SINGAPOREAN NOTICES TO MARINERS

*(NM 81P/2015) TEMPORARY RE-ALIGNMENT OF TEMASEK FAIRWAY AND WEST JURONG CHANNEL

Edition No. 9A/2015

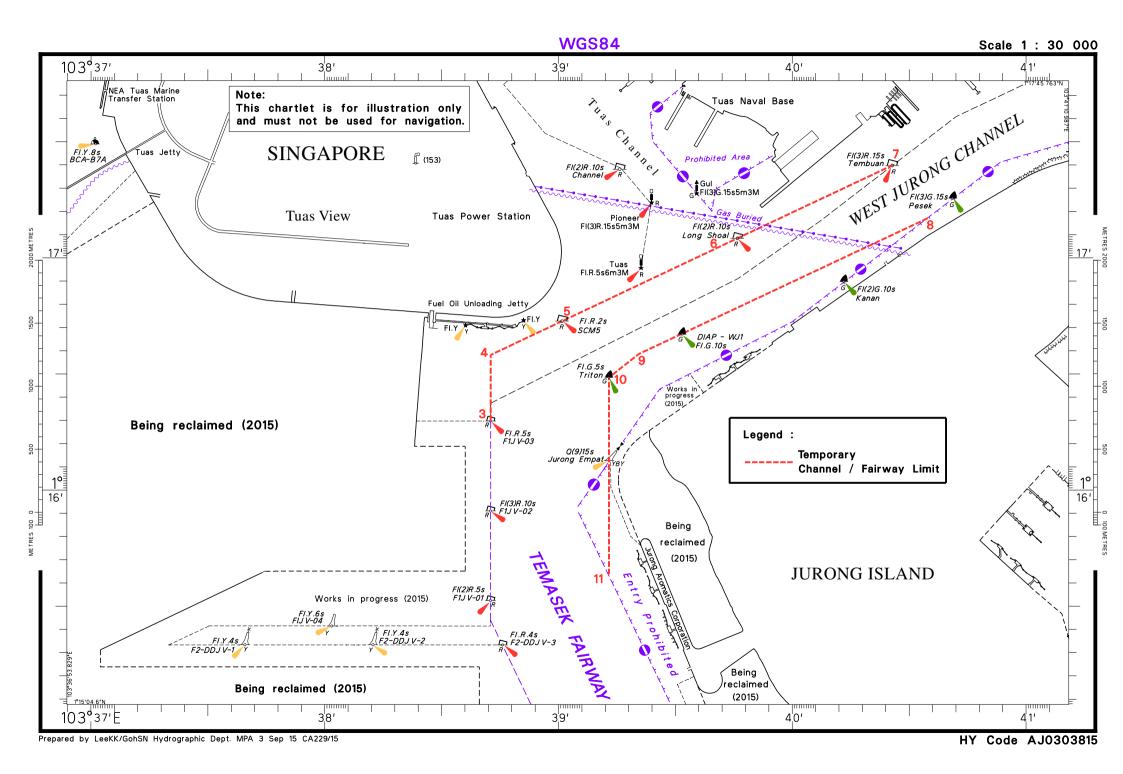
- The Maritime and Port Authority of Singapore (MPA) would like to inform mariners that the boundaries of Temasek Fairway and West Jurong Channel will be re-aligned. The re-alignment includes changes to the boundaries of the existing Temasek Fairway and West Jurong Channel and re-location of navigational buoys. The re-alignment will come into effect at 0001H on 1 October 2015.
- 2. The revised boundaries of Temasek Fairway and West Jurong Channel are bounded by a line joining the following geographical positions:

(WGS 84 Datum)			
		Latitude (N)	Longitude (E)	
Temasek Fairway line joining	(3)	1°16·297'	103°38·709'	F1JV-03 Buoy
to:	(4)	1°16·582'	103°38·709'	
Temasek Fairway line joining	(11)	1°15·630'	103°39·216'	
to:	(10)	1°16·485'	103°39·216'	Triton Buoy
West Jurong Channel line joining	(4)	1°16·582'	103°38·709'	
	(5)	1°16·727'	103°39·015'	SCM 5 Buoy
	(6)	1°17·084'	103°39·765'	Long Shoal Buoy
to:	(7)	1°17·400'	103° 40·432'	
West Jurong Channel line joining	(10)	1°16·485'	103°39·216'	Triton Buoy
, ,	(9)	1°16·585'	103°39·342'	•
		1°16·671'	103°39·529'	DIAP-WJ1 Buoy
to:	(8)	1°17·170'	103° 40·579'

- 3. These changes are shown in the accompanying diagram, however there may be amendments as the work progresses. Mariners are advised to consult local authorities and refer to updated information available in relevant MPA Port Marine Notices at http://www.mpa.gov.sg.
- 4. Charts affected: Singaporean Charts GSP1, SP1 and 501.
